SUBJECT: NORTH ANNA POWER STATION (NAPS), UNIT NOS. 1 AND 2, FOURTH
10-YEAR INSERVICE TESTING INTERVAL PROGRAM, PUMPS AND VALVES
RELIEF REQUEST (RR) (TAC NOS. ME2776 AND ME2777)

SAFETY EVALUATION BY THE OFFICE OF NUCLEAR REACTOR REGULATION

RELIEF REQUEST NO. P-6

NORTH ANNA POWER STATION, UNIT NOS. 1 AND 2

Figure P-6
Outside Recirculation Spray Pump - Head-Flow Curve

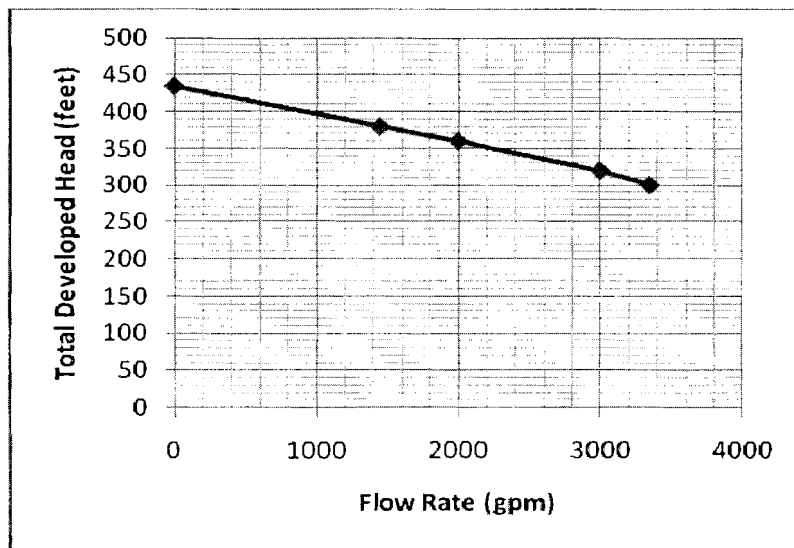
In lieu of testing through the spray headers or temporary full flow test loops, the licensee proposes to perform comprehensive and preservice pump testing using the 4-inch recirculation test loop line. Due to the size of this line, pump flow will be restricted and a flow rate within 20% of the design flow rate (3350 gpm) cannot be achieved. The design flow rate is the same as accident flow rate.

As an alternative to the testing within 20% of the design flow rate, as required ISTB-3300(e)(1), the licensee requested to set the reference value flow rate, of the outside recirculation spray pumps, at 1450 gpm during comprehensive pump testing. This is within approximately 57% of the design flow rate. Additionally, as an alternative to measuring at least five points for the preservice test, over a range of the pump minimum flow rate to at least the pump design flow rate, as required by ISTB-3100(b) and ISTB-5210(a), the licensee proposes to obtain the five points between the minimum flow rate and approximately 43% of the design flow rate.

Normally, pump testing at design flow is required because the reduction in the total developed head (TDH) increases as the pump flow increases. In the low flow region of the pump curve, increasing internal flow rates, as a result of internal wear, are difficult to detect. Pumps with flat curves in the at low flow region, should be tested at or near design conditions to determine if increasing internal recirculation flows have degraded pump performance to the point where design performance cannot be met. However, for the outside recirculation spray pumps at NAPS, Unit Nos. 1 and 2 the pump curves are not flat but highly sloped at approximately 43% of the design flow (Figure P-6). The NRC staff determined that testing at 43% of the design flow rate should allow for detection of degradation in the outside recirculation spray pumps, since the TDH changes noticeably with increased flow in this area of the pump curve. The following data (Table P-6) and curve (Figure P-6) for the pumps are derived from Figure P-6.2m, ADAMS Accession No. ML093350600:

Based on a review of the pump curves information provided by the licensee and the description of the pump monitoring in the NAPS, Unit Nos. 1 and 2 PdM Program, the NRC staff finds that the alternative testing at lower flow rates for the outside recirculation spray pumps, 1-RS-P-2A/2B and 2-RS-P-2A/2B, provides reasonable assurance of the operational readiness of these pumps. Compliance with the specified ASME OM Code requirements would result in hardship without a compensating increase in the level of quality and safety.
